## IMPROVED BEARING

Keeping the tail rotor drive shaft bearings on your Kiowa (OH-58A) lubed is a chore you can soon forget.

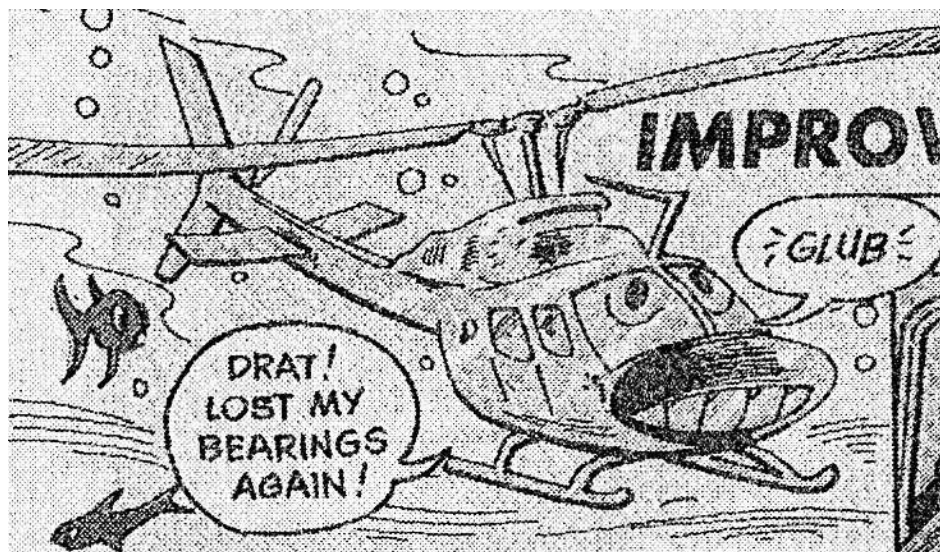
Put in the new-type bearings with an improved lubricant and better seal . . . FSN 3110-106-8664.

From then on, eyeball the bearing every 50 hours to make sure it's in operating condition. You never have to lube the new bearing. Just replace it every 600 hours.
